Michael Collins Architect LLP

6 Chaomans Letchworth
Job No. **188** Elevations West AA
as proposed

Stage: Stage 3
Status: **Non-material amendment**

East Elevation DD as Proposed

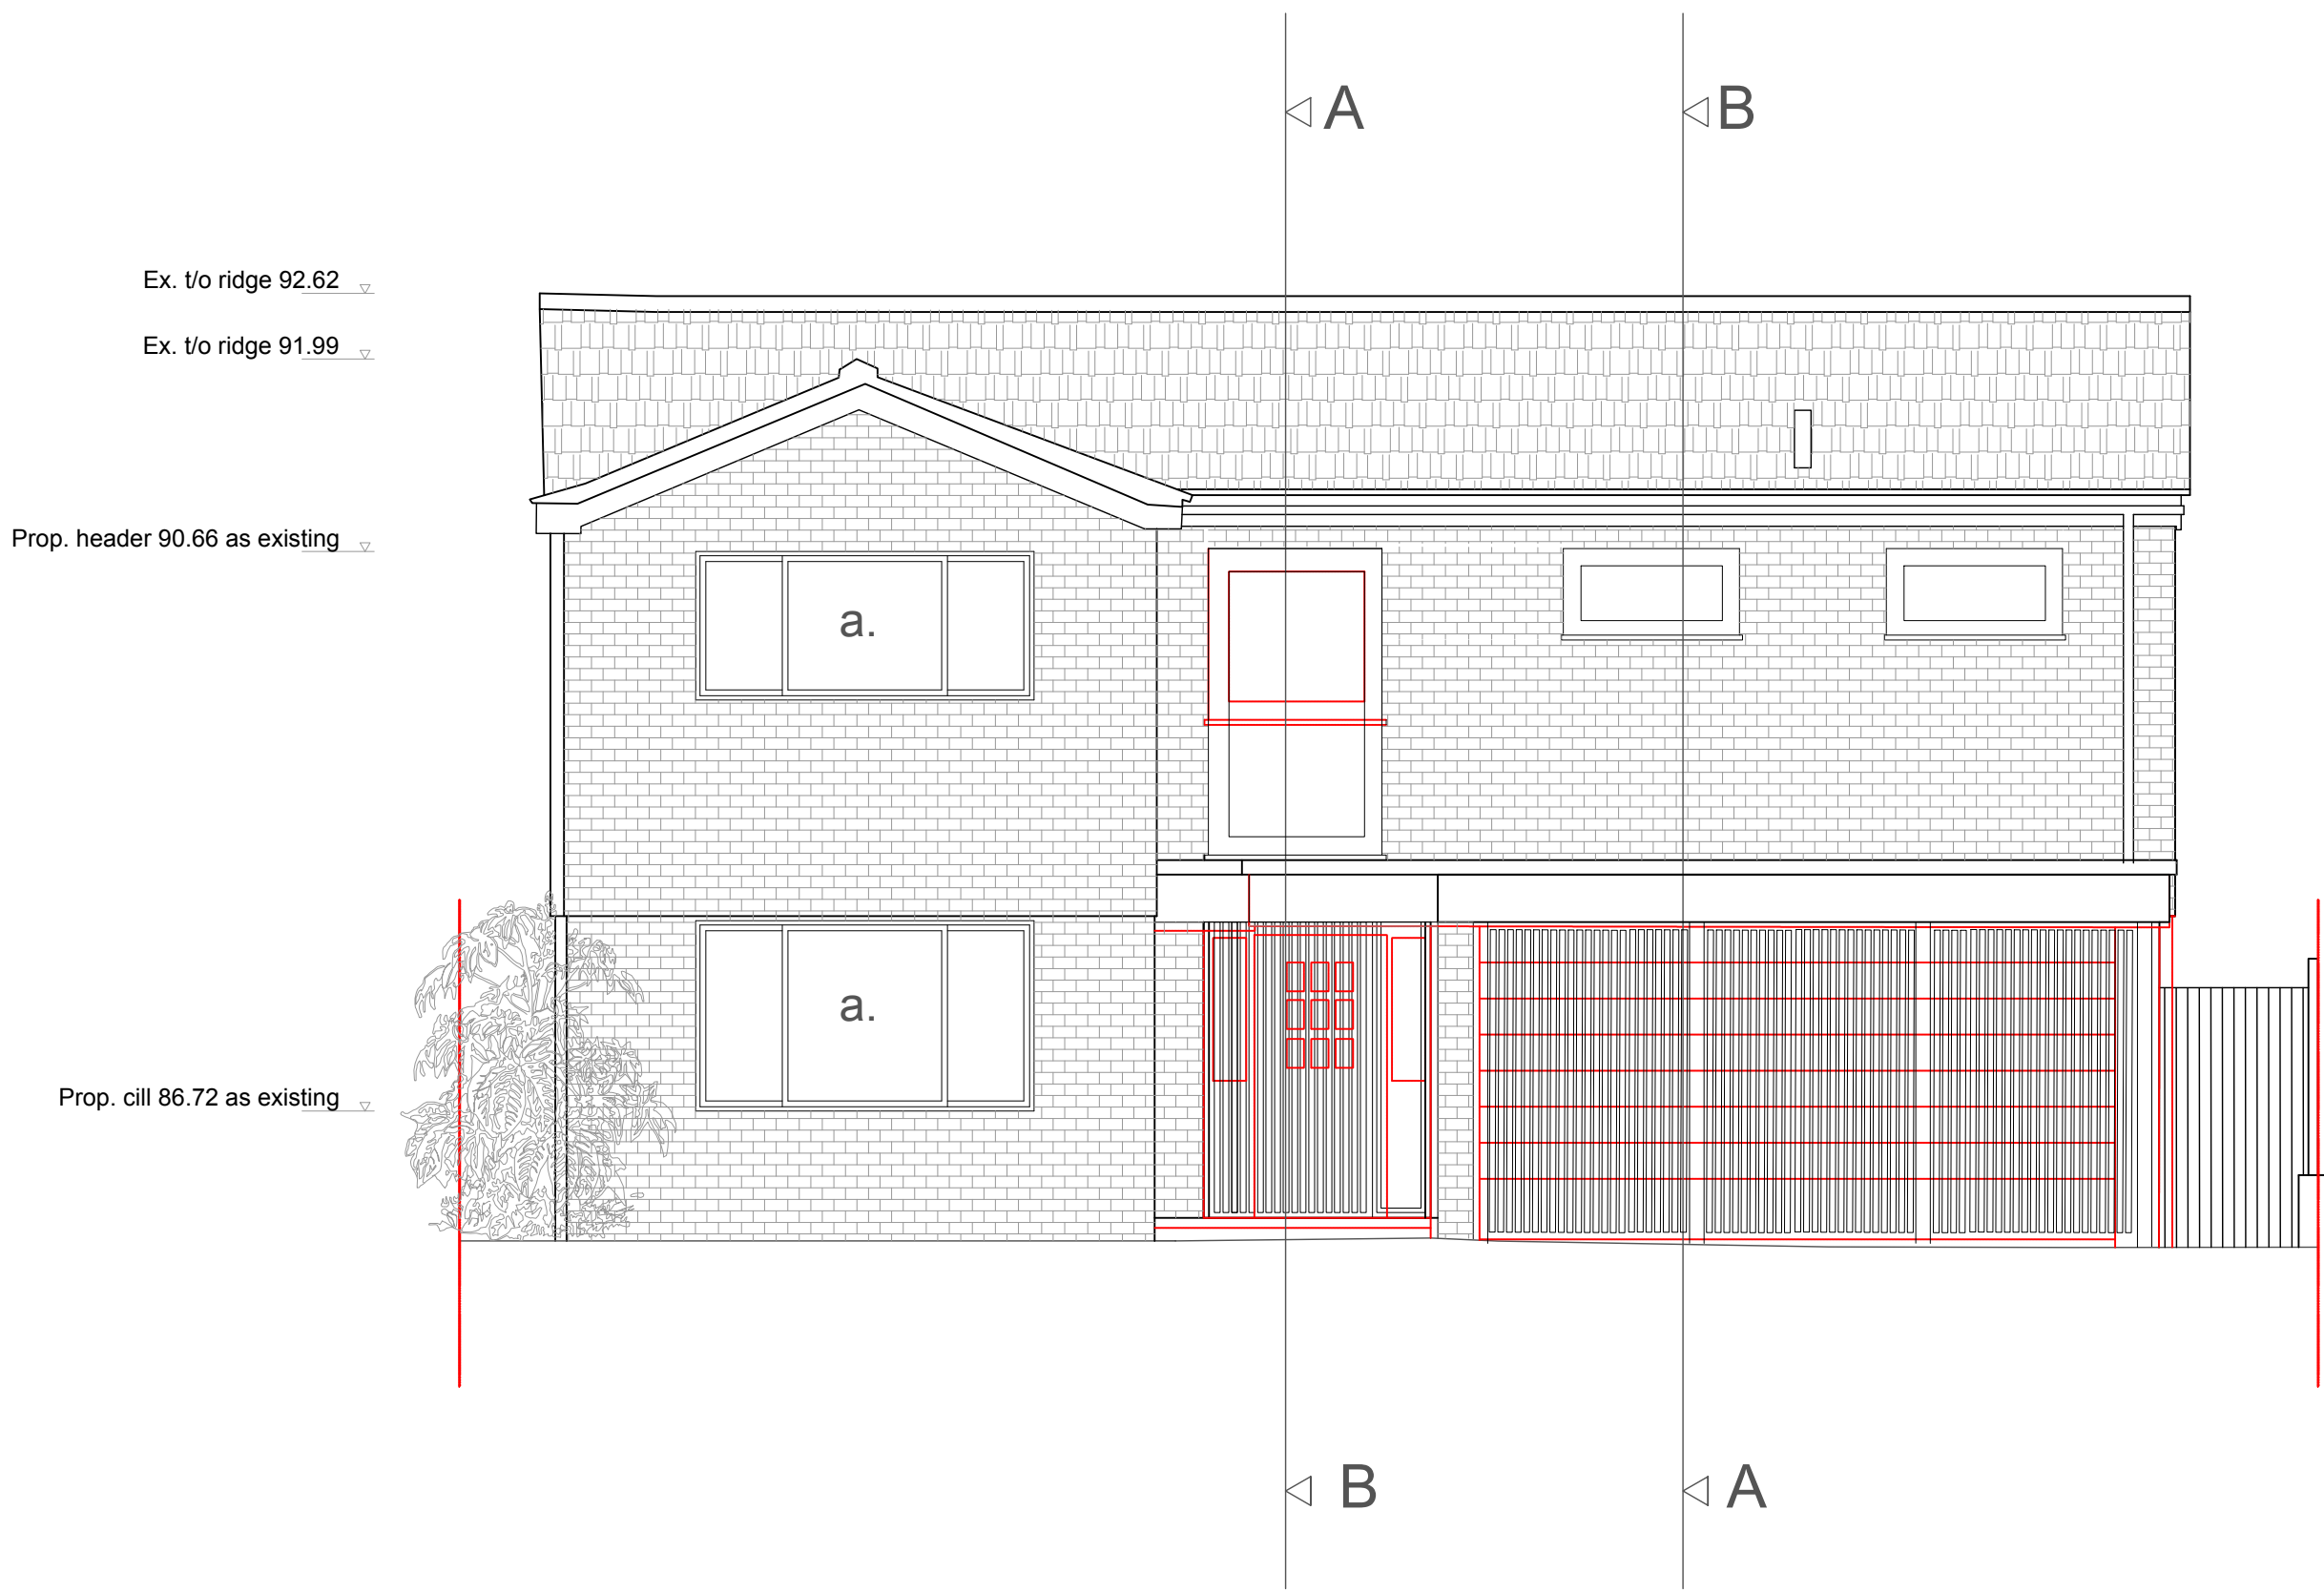
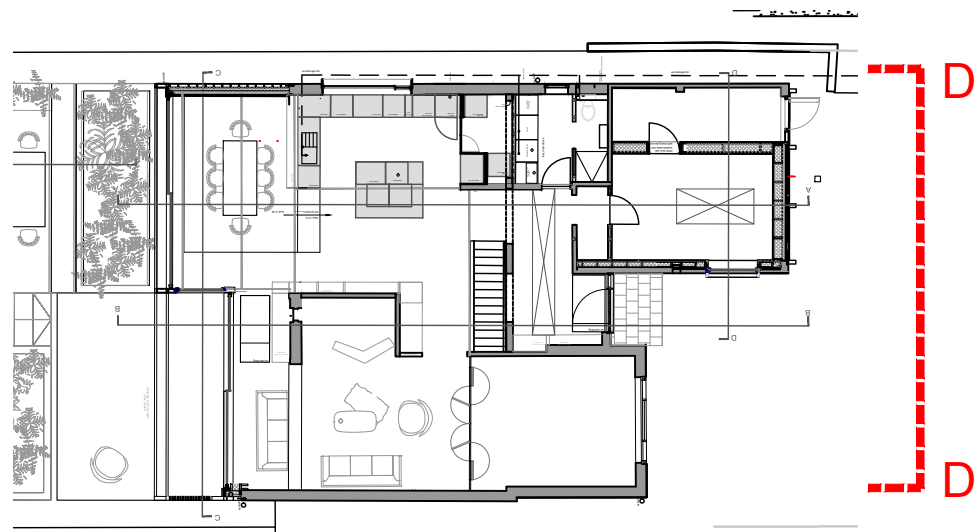
- a. Replace white UPVC existing windows with **aluminium** window - white
- b. New timber front porch door with fixed glazing panel
- c. Existing brick wall
- e. New rooflight
- f. New aluminium RAL 7013 cladding frame**
- g. New **iroko** timber cladding and louvered screen
- h. Existing side gate
- i. New brick wall to match existing
- j. New slimline aluminium sliding doors bronze anodised
- k. New flat roof
- l. Widflower flat roof
- m. Aluminium flashing **RAL 7013**
- n. White fascia
- o. New door - wood
- p. New slimline aluminium windows **RAL 7013**
- q. Oak frame for window
- r. New PV panels
- s. New **white aluminium** window white to match the adjacent windows
- t. Replace existing UPVC windows with aluminium window RAL 7013**
- u. Seamless glazed balustrade**
